# Service Bulletin

Bulletin No.: RS-74  
                   Rev. 1  
 Date: 11/15/80  
 Revised: 8/15/86

**Subject:** NOZZLE ASSEMBLY, AIR BLEED, P/L 2524041-2 TO -3 MODIFICATION OF.

Figure 1.

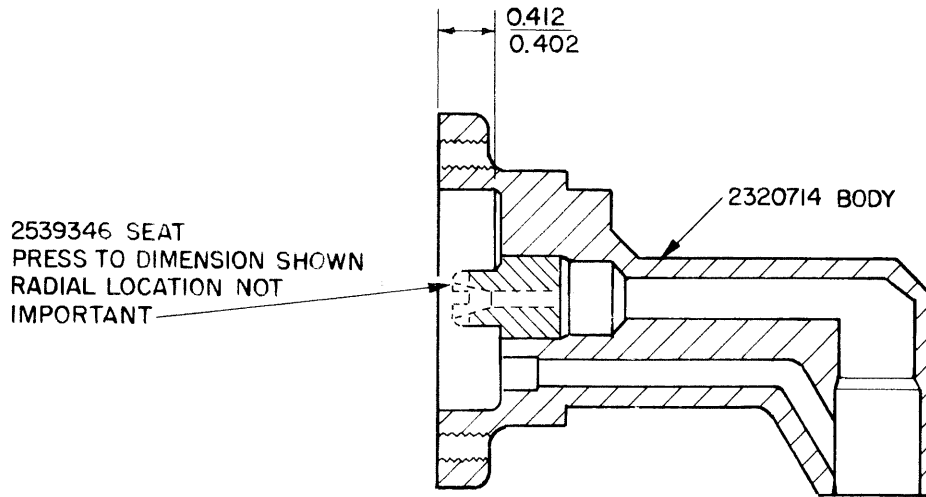
(3) Press the new Part Number 2539346 seat into body with an arbor press to the dimension indicated in Figure 1 of this directive. Wipe excess sealant from the bushing and body with MEK or acetone.

Figure 2.

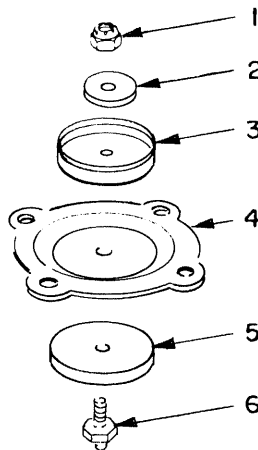
(4) Assemble together parts (1 through 6, Figure 2) of this directive and tighten nut (1) to a torque value of 5-7 inch-pounds. Retorque to original value after 20 minutes. Retorque only.
